ADDENDUM 01

Addendum to the drawings and specifications for:
Kendall County – Emergency Medical Services Station No. 3

EMERGENCY MEDICAL SERVICES STATION NO.3

10.06.23

2 SECTION DETAIL
1/2" = 1'-0" WATER WELL

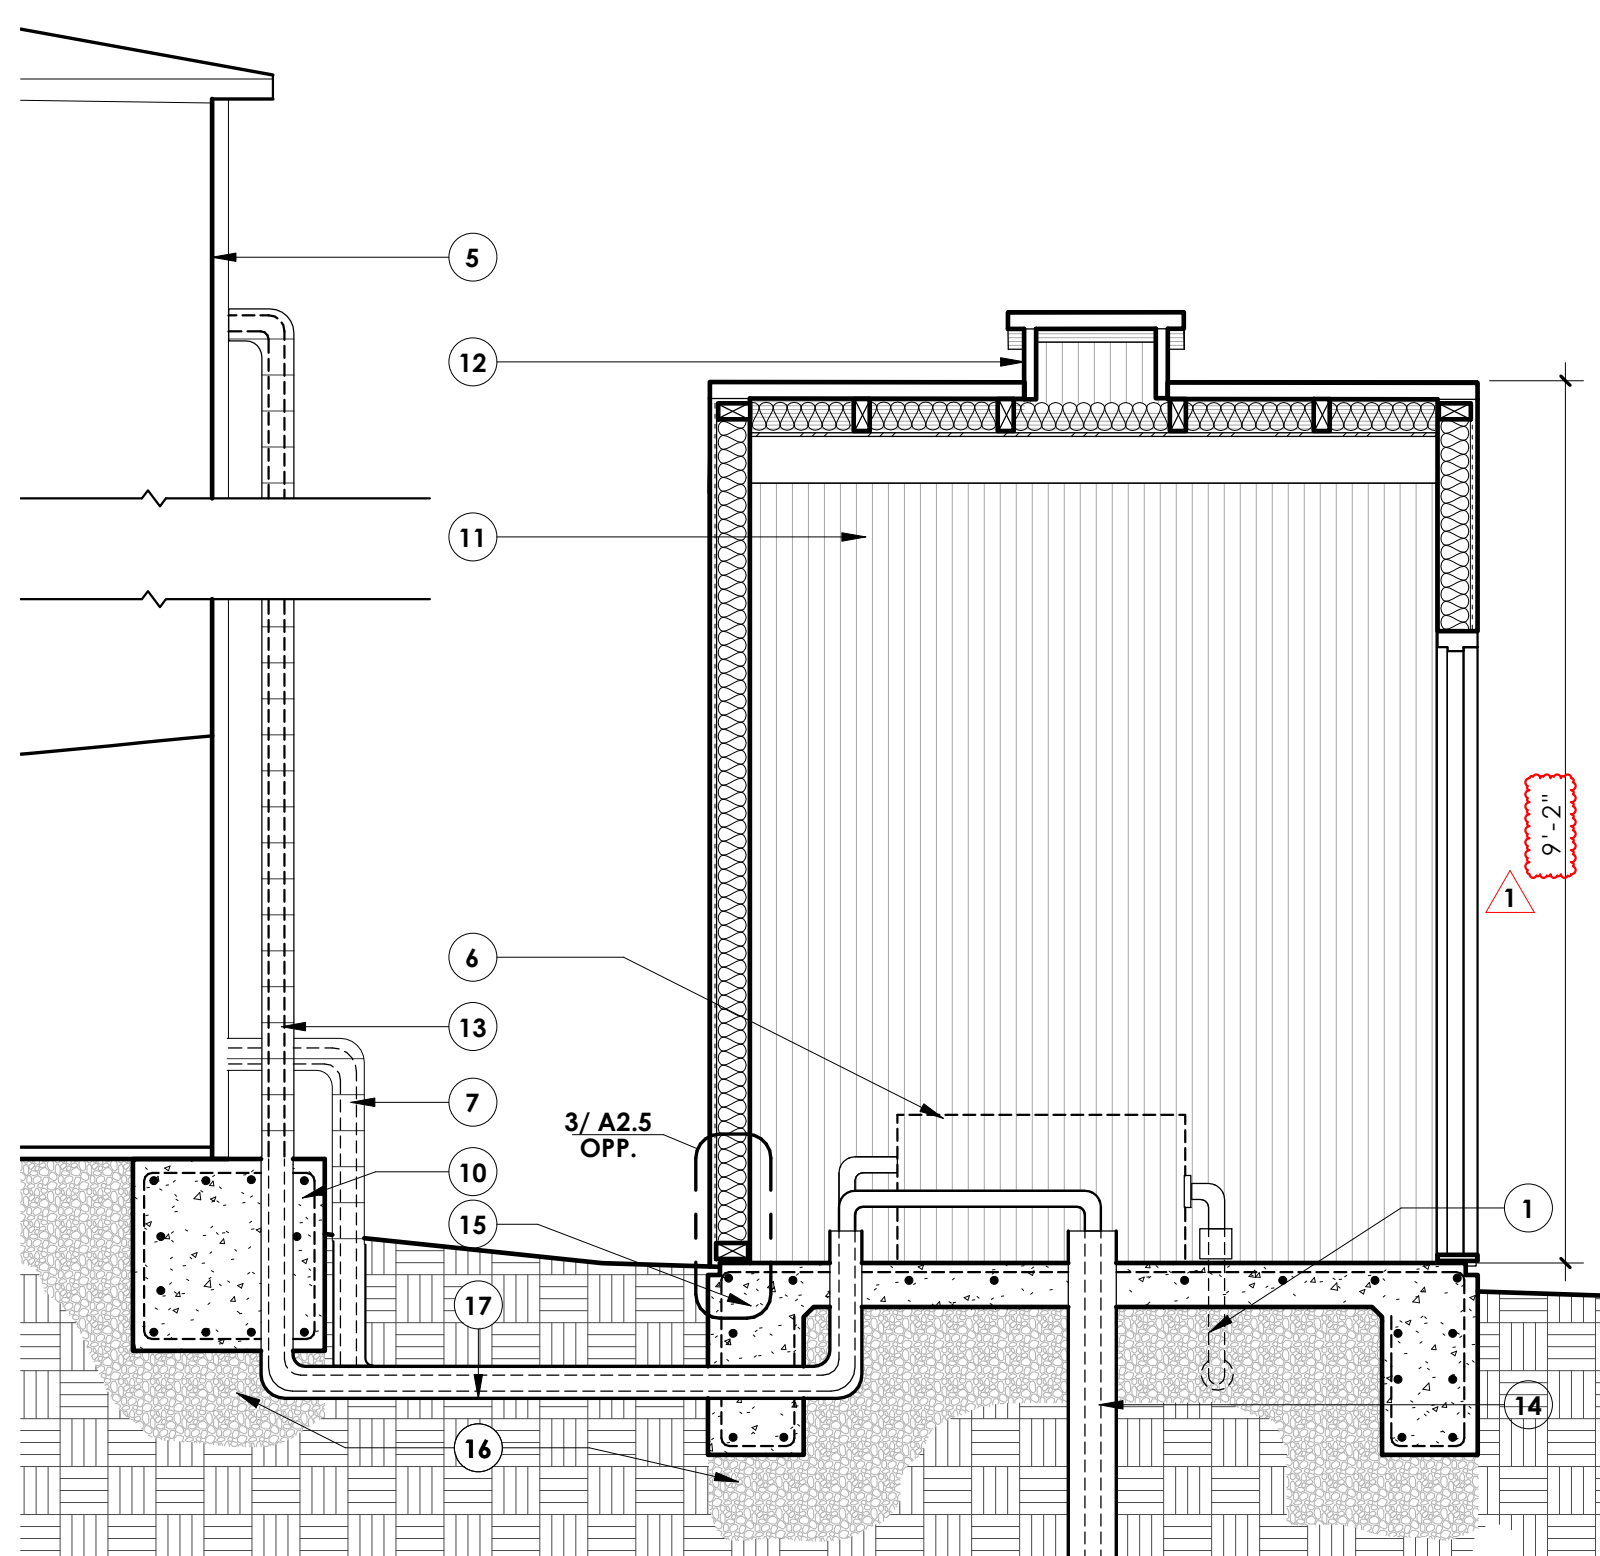
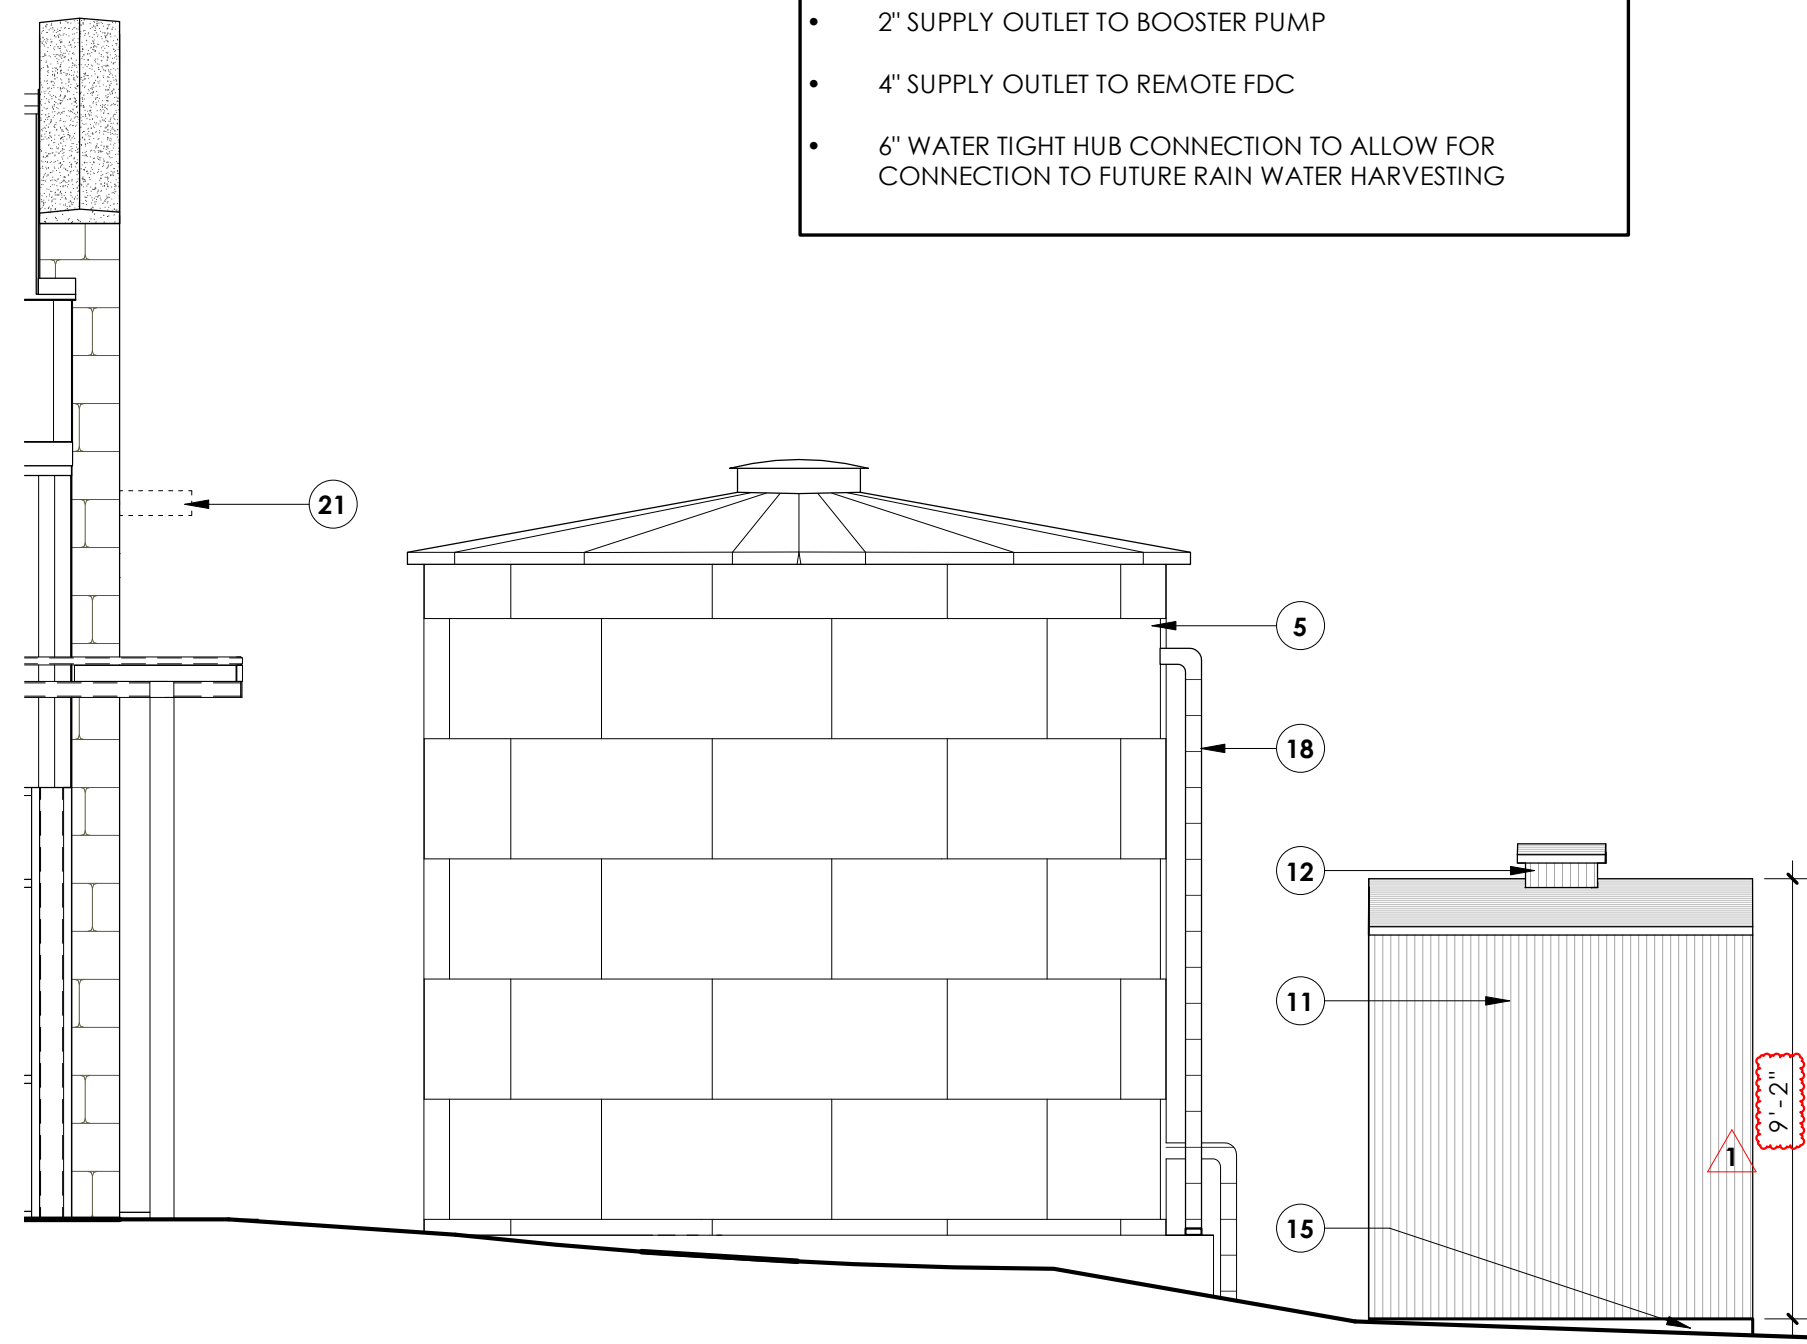
Item 1.10 – Updates Water Well Sheets A2.4 and A2.5

Dimensions on Dog House and Special Water Well Notes updates per water well questions and responses below.

Response to Question 3: *Refer to added dimensions on updated sheet A2.4 & A2.5 for clarification.*

Response: Provide 3 HP Domestic Water Booster Pump with 208 volt single phase power sized to provide 41 gpm at 60 to 70psi. Refer to updated sheets A2.4, A2.5, and E1.0

Response: Yes, provide and install a low water level alarm to be set at 40% capacity of the domestic water tank. Refer to updated sheets A2.4, A2.5,.

layout can be coordinated and confirmed during construction. Refer to updated keynote 23 & 17 on sheet A2.4 , A2.5.

A3.1

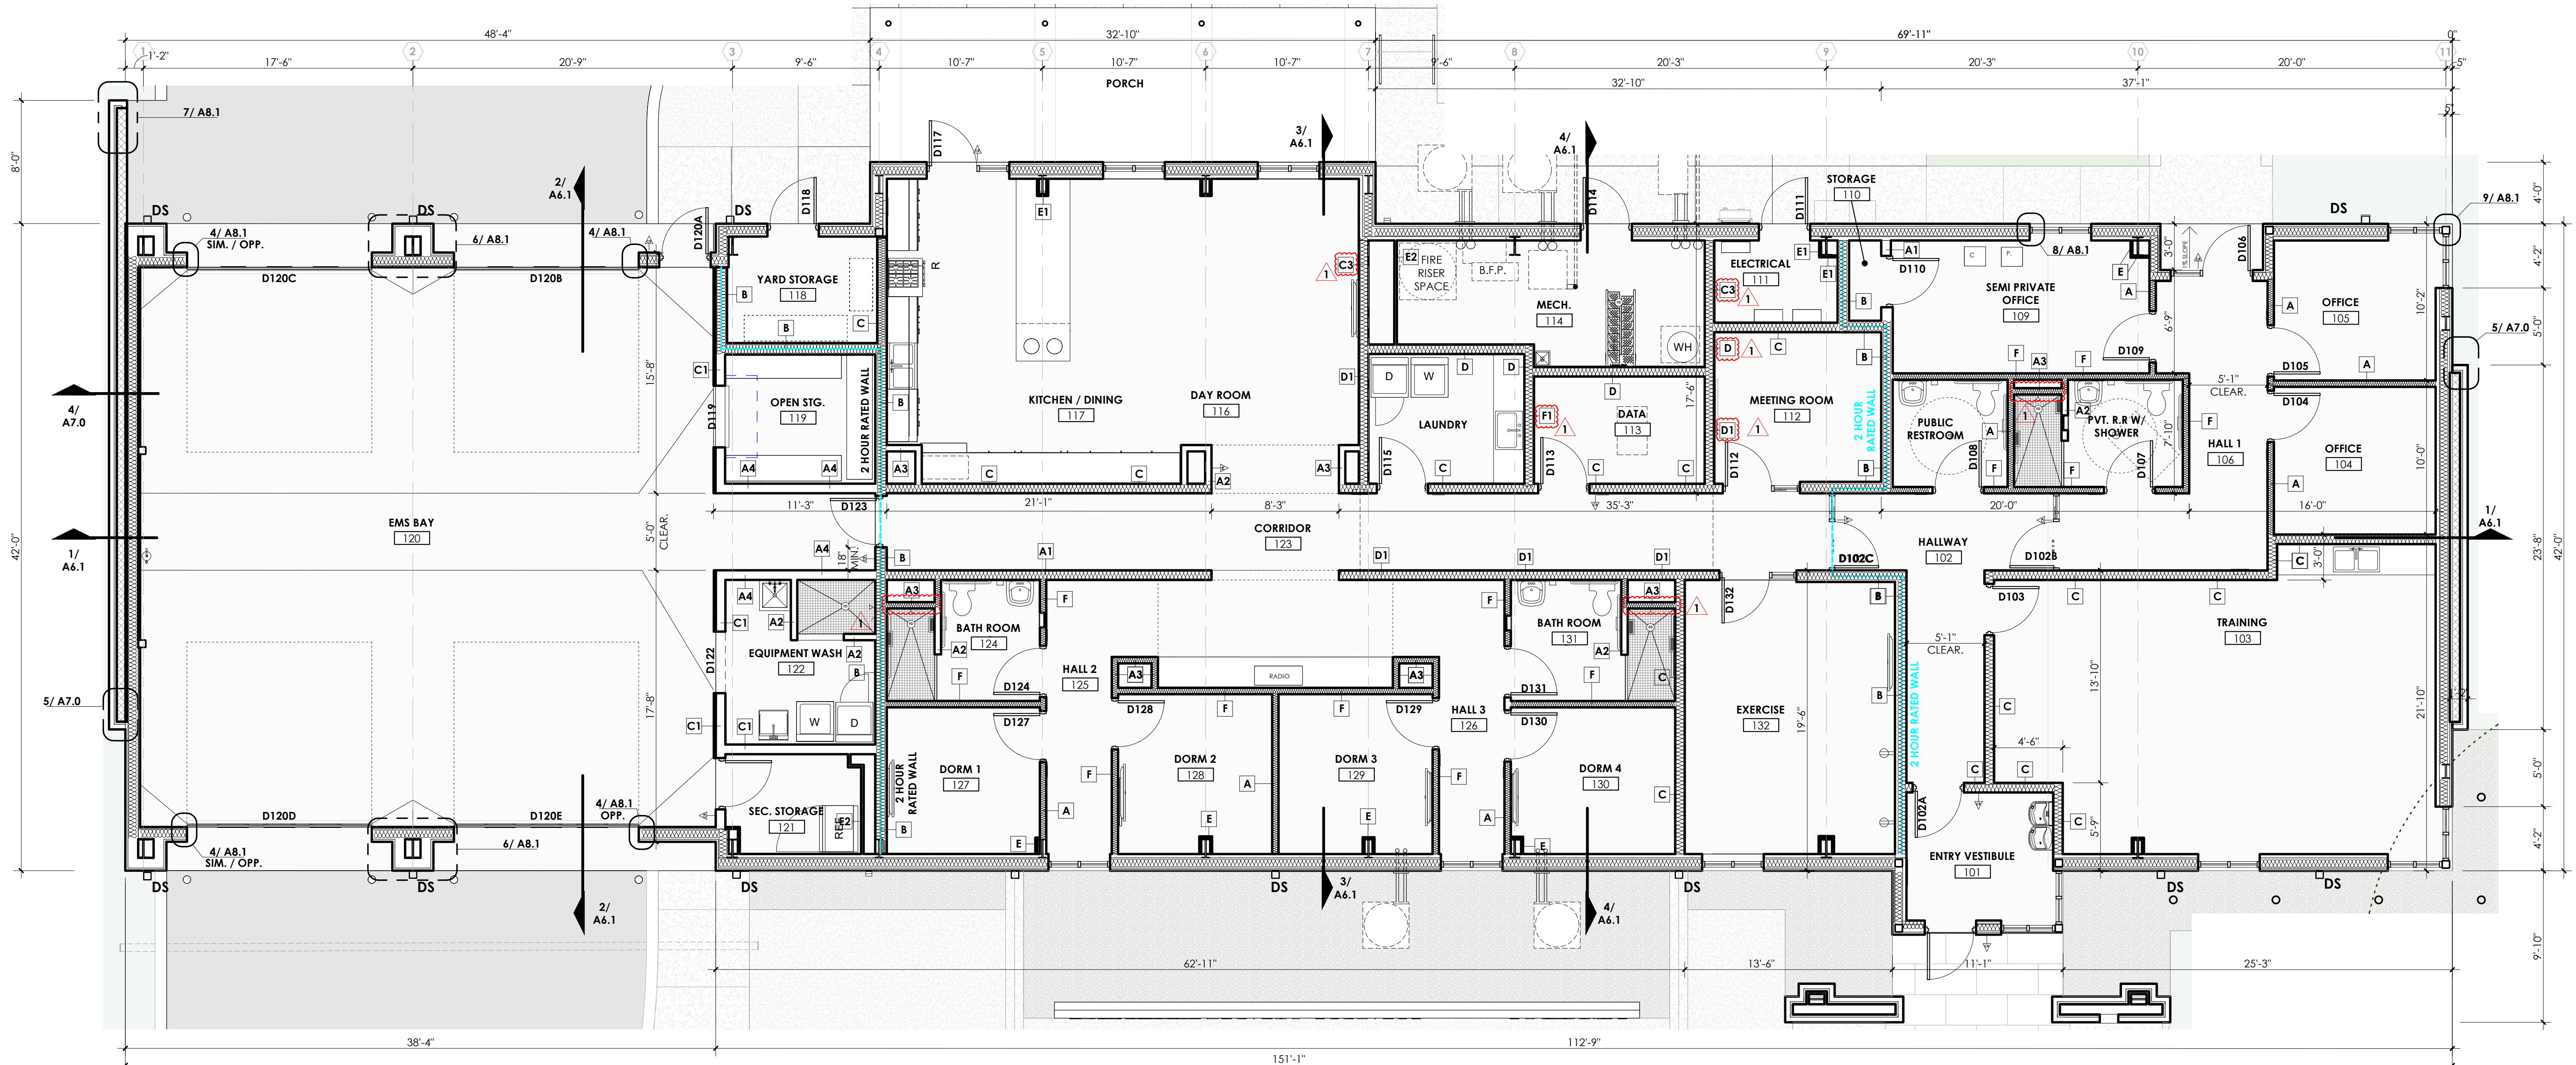
7. **Question:** The finish schedule on A1.4 has the data room ceiling as EX, but the RCP shows ceiling tile. Please advise which option should be included in the proposal?

Response to Question 7: Provide exposed EX ceiling in data room, refer to revised Room Finish Schedule updated on A1.4 and updated Reflected Ceiling Plan on Sheet A3.1.

A4.0
© 2023 Bealy Palmer Architects, Inc. all rights reserved. no part of this document may be reproduced or utilized in any form without prior written authorization of bealy palmer architects, inc.
BEATY PALMER ARCHITECTS

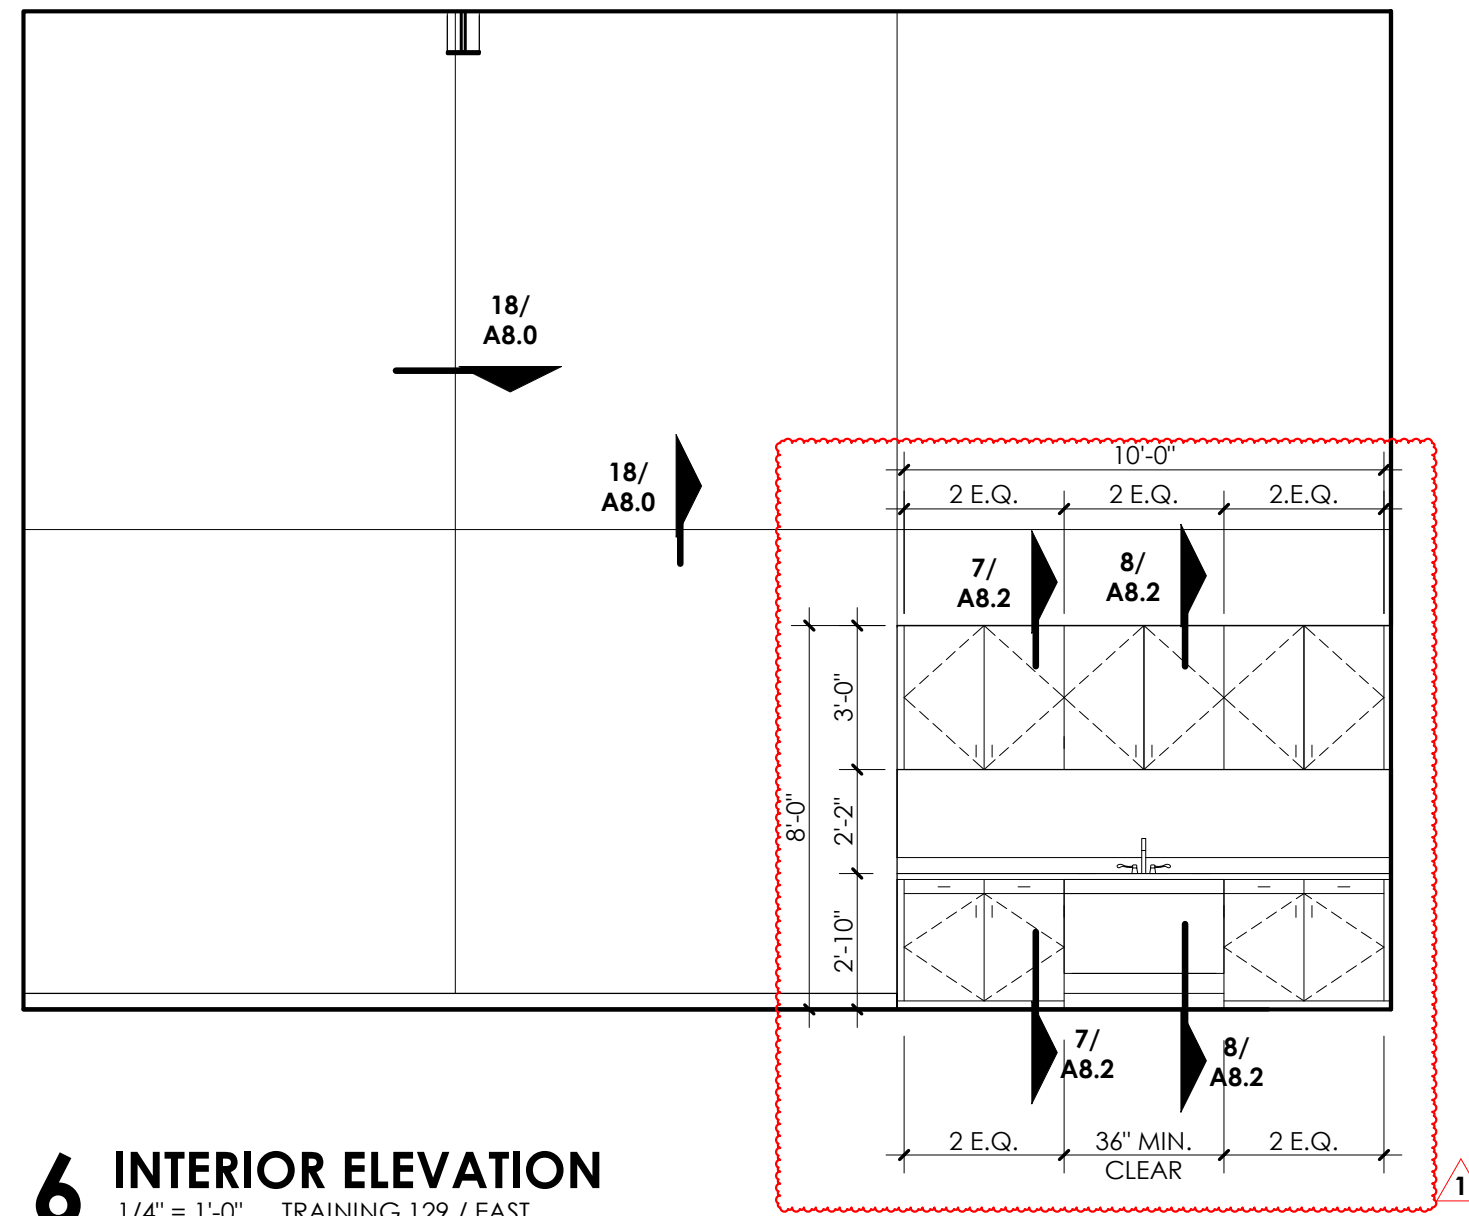
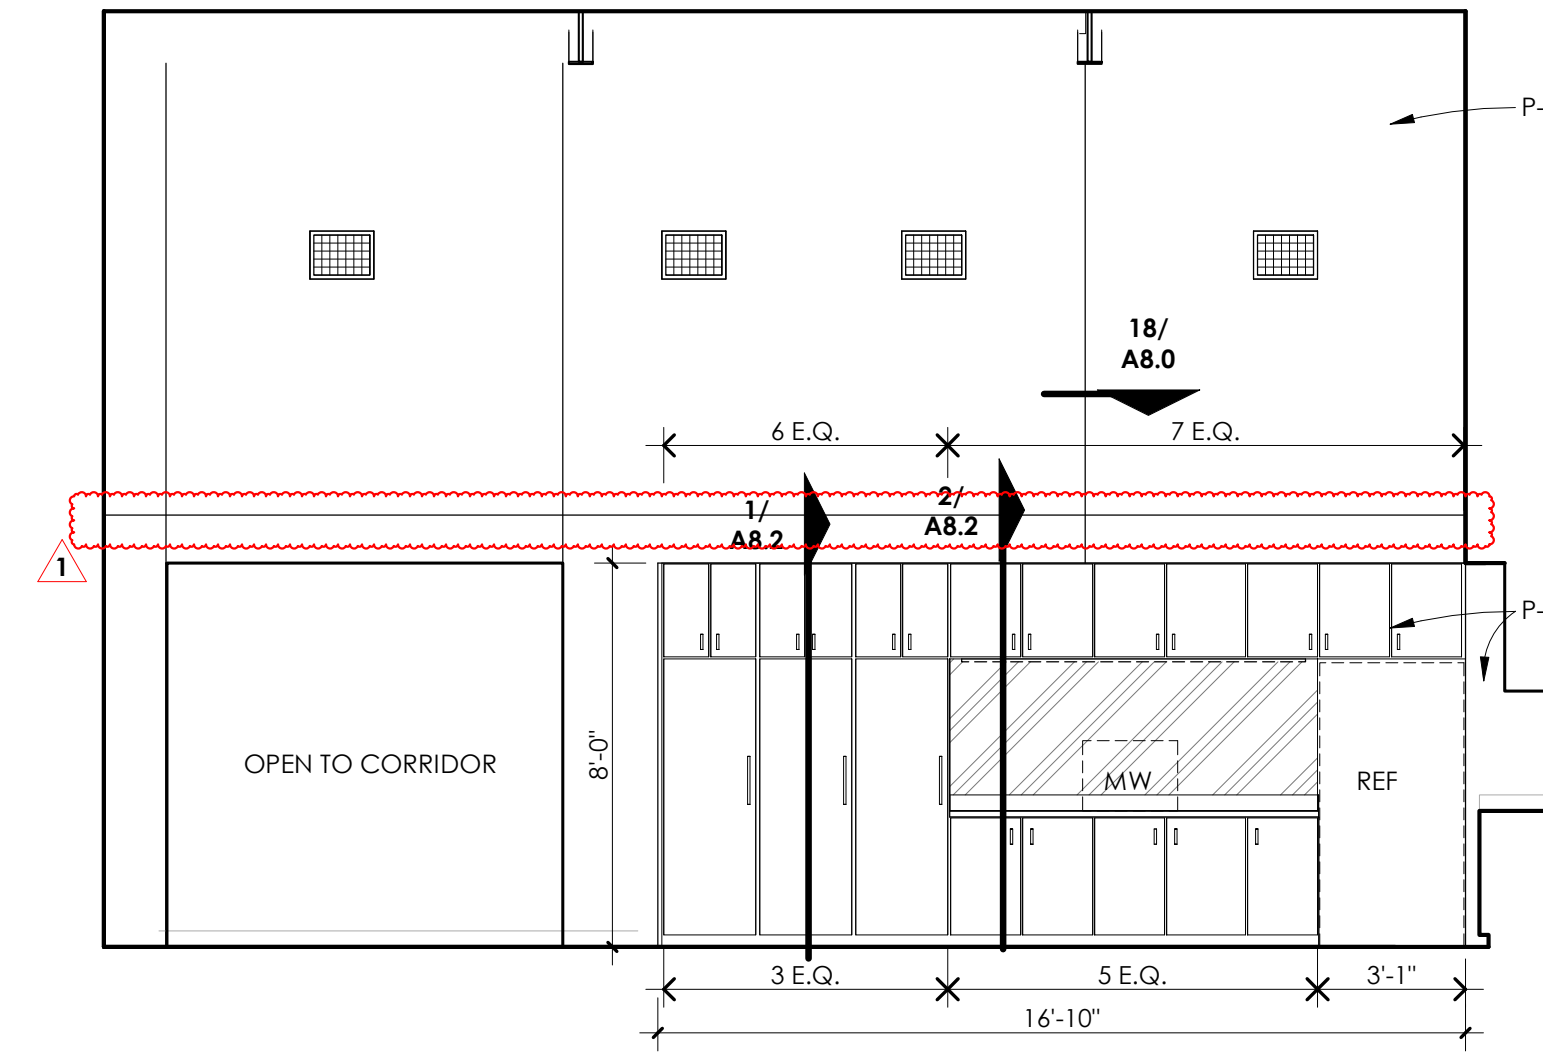
Refer to revised sheet A4.0 for the revised shower configuration of Bathroom 123 . 131 & Private R.R. With Shower 107 to allow for adaptable design / ADA.

Refer to revised sheet A4.0 and P2.1 & S-1.1 for revising the shower compartments size & water controls to on the plan west walls of Bathroom 123 . 131 & Private R.R. With Shower 107 to ensure compliance with T.A.S.

Response to Question 25 : TA-9 is intended to be a 48" horizontal grab bar with panned grip (typical 1 per personnel shower location) refer to revised sheet A4.0
